SECTION 00 9113
ADDENDUM NUMBER 3

DATE: August 3, 2016

RSMP Phase 2A
James Monroe High School
RFI LOG
8/3/16

DRAWING NUMBER:
ADD2-SK-P-07

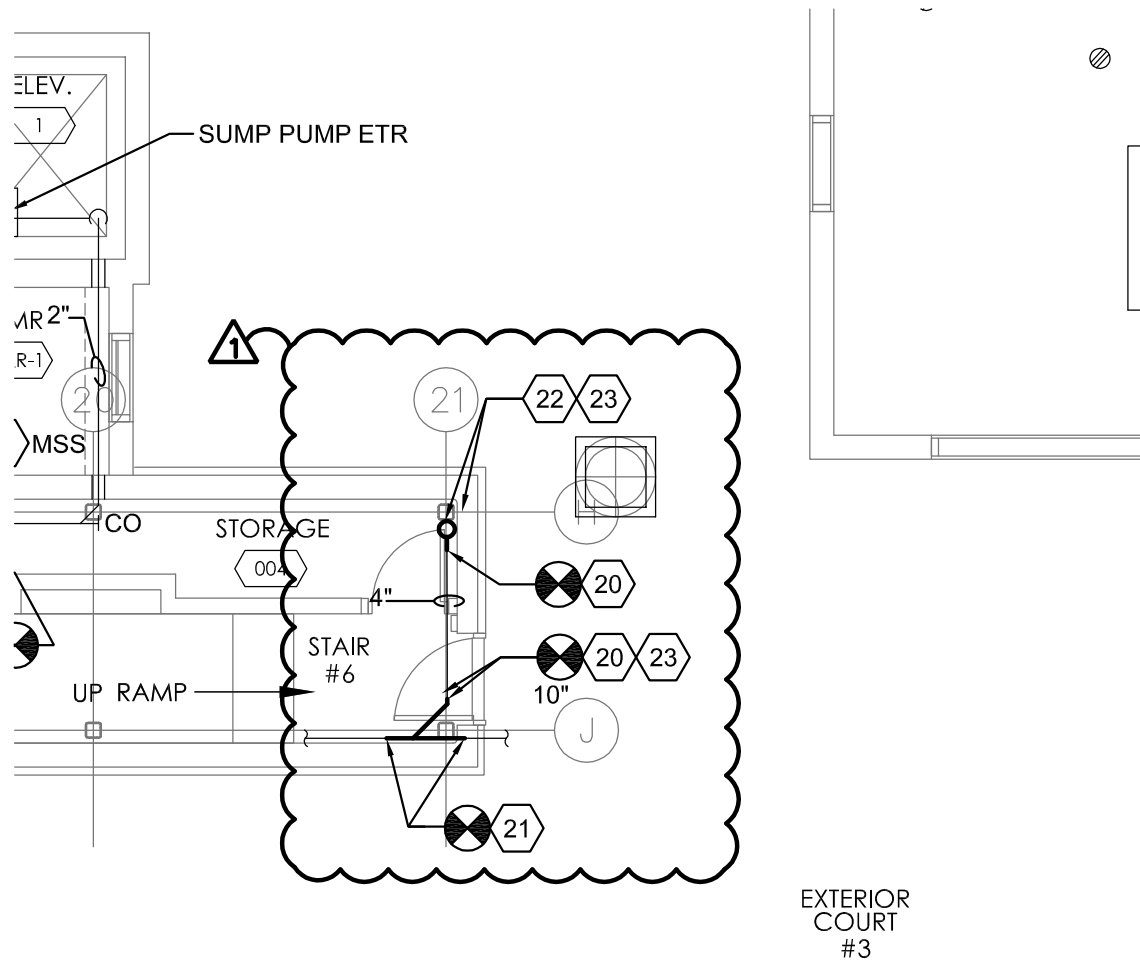
- A. Change and relocate below slab storm and sanitary sewer piping locations at columns 22h and 22J. "Refer to Sketch ADD2–SK-P-07".

DRAWING REFERENCE NUMBER(S): AS NOTED
DRAWING NUMBER: ADD2-SK-P-08

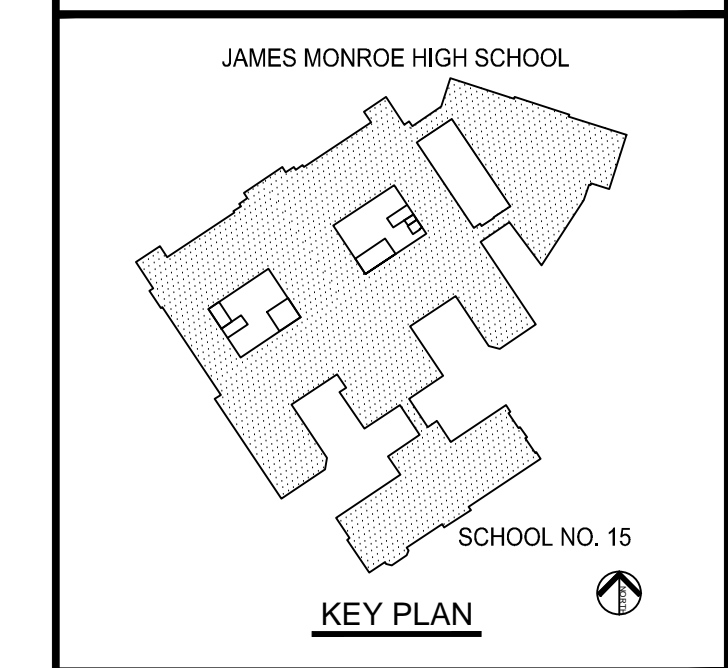
- A. Change and relocate below slab storm and sanitary sewer piping locations at columns 21h and 21J "Refer to Sketch ADD2–SK-P-08".

DRAWING NO.
C001

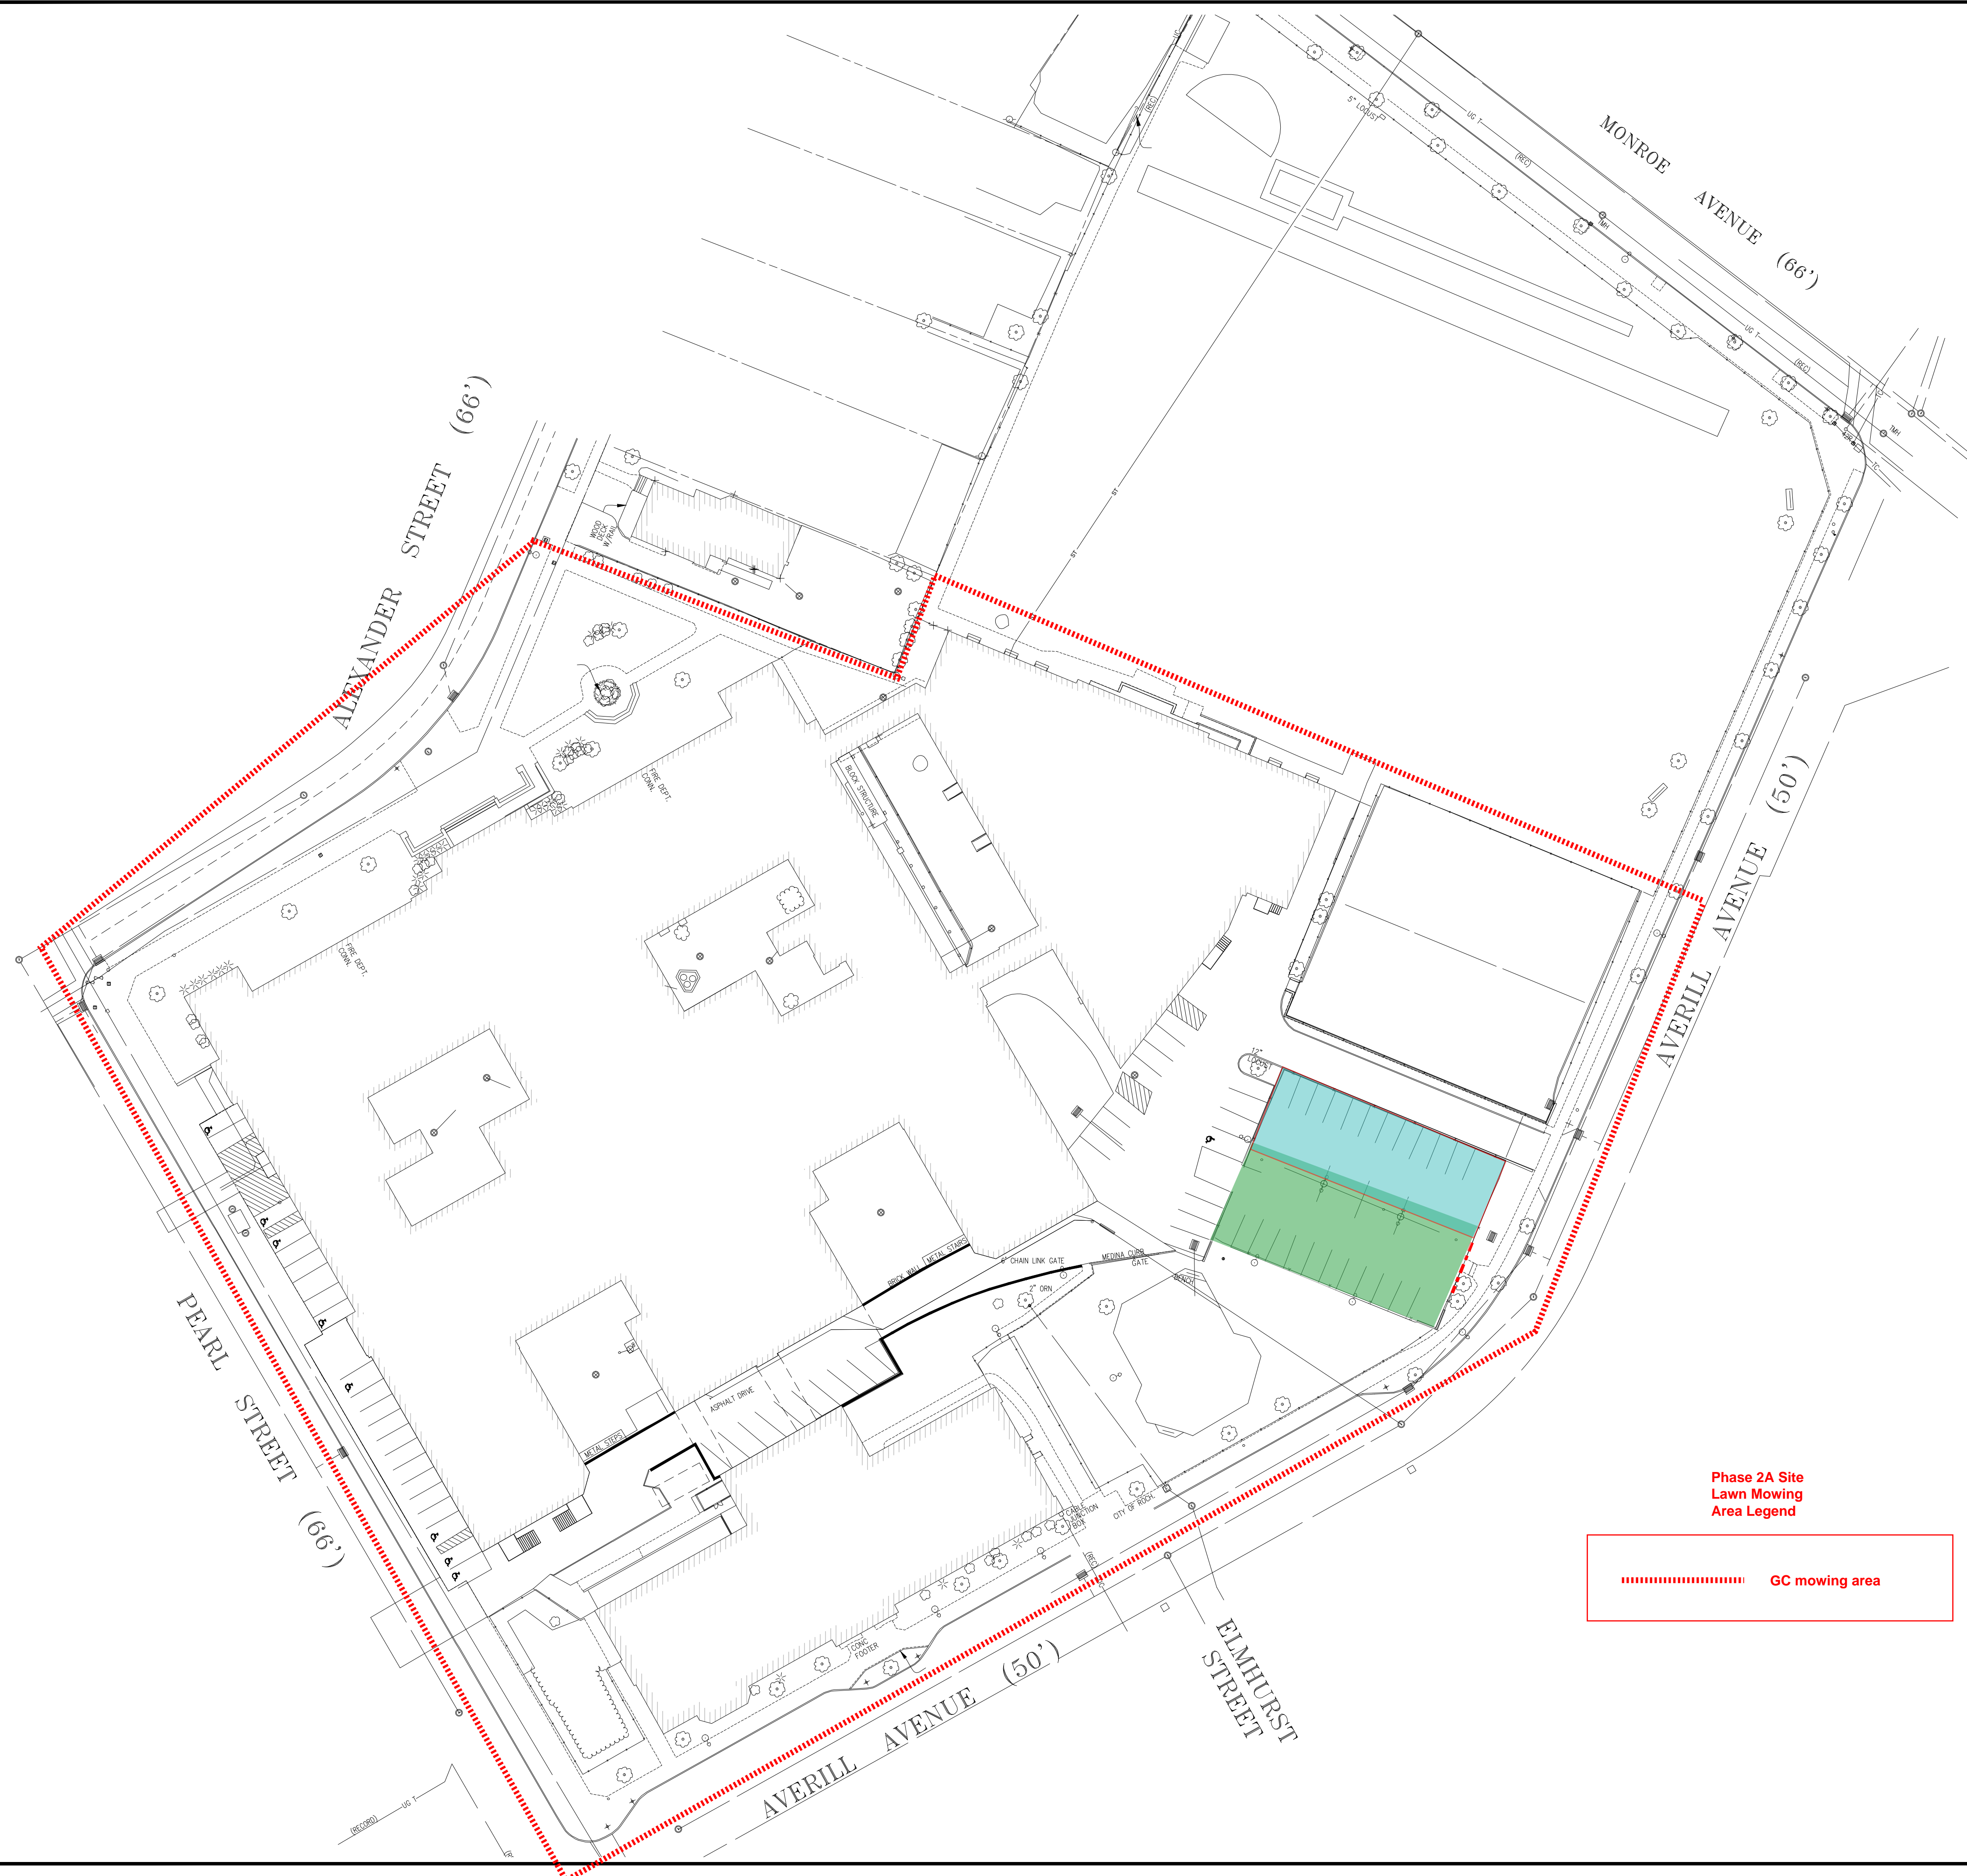
- A. RFI Log, dated 8/3/2016 (3 pages).
- B. Site Walk-through sign in sheet (7/18/2016)
- C. Site Walk-through sign in sheet (7/25/2016)
- D. Section 11 4000 Food Service Equipment
- E. Sketches:
 - ADDSK-A-05 Stair #2 Keynotes
 - ADDSK-A-06 Typical Door Bulkhead Detail
 - ADD3-M1 Additional Chilled Beam Terminal Schedule
 - ADD3-M2 Screening 139 Smoke Damper Plan
 - ADD2-SK-P-01 Partial Basement Plumbing Removal Work
 - ADD2-SK-P-02 Partial Basement Plumbing Plan
 - ADD2-SK-P-03 Partial Third Floor Removal Plan
 - ADD2-SK-P-04 Partial Basement Removal Plan
 - ADD2-SK-P-05 Partial Basement removal Plan
 - ADD2-SK-P-06 Partial Basement Removal Plan
 - ADD2-SK-P-07 Partial Basement Removal Plan
 - ADD2-SK-P-08 Partial Basement Plumbing Plan
- F. Drawings:
 - C001 Site Demolition Plan – (Phase 2A Site Lawn Mowing Area outline)

42	07/29/16	Please clarify the extent of lawn maintenance required under the general trade's contract. A site drawing detailing exact grass locations to maintain is best. Please advise.	See specifications section 011200 Multiple Contract Summary for lawn mowing requirements, as well as attached sketch CM-01 GC Mowing Area.
43	07/29/16	Please clarify the scope of work between alternate 6 and base bid pertaining to wood doors, frames and hardware. The door schedule indicates all doors are NEW, base bid indicates that existing doors shall receive new BUTT style hinges and alternate 6 indicates new doors will receive continuous hinges. Are flush wood doors base bid or an alternate, do all doors require continuous hinges per district standard and will the door, frame and hardware schedules be revised to reflect the outcome of this response, please advise.	See Addendum No 3 for clarification to base bid butt hinges and Alternate GC-06 description.
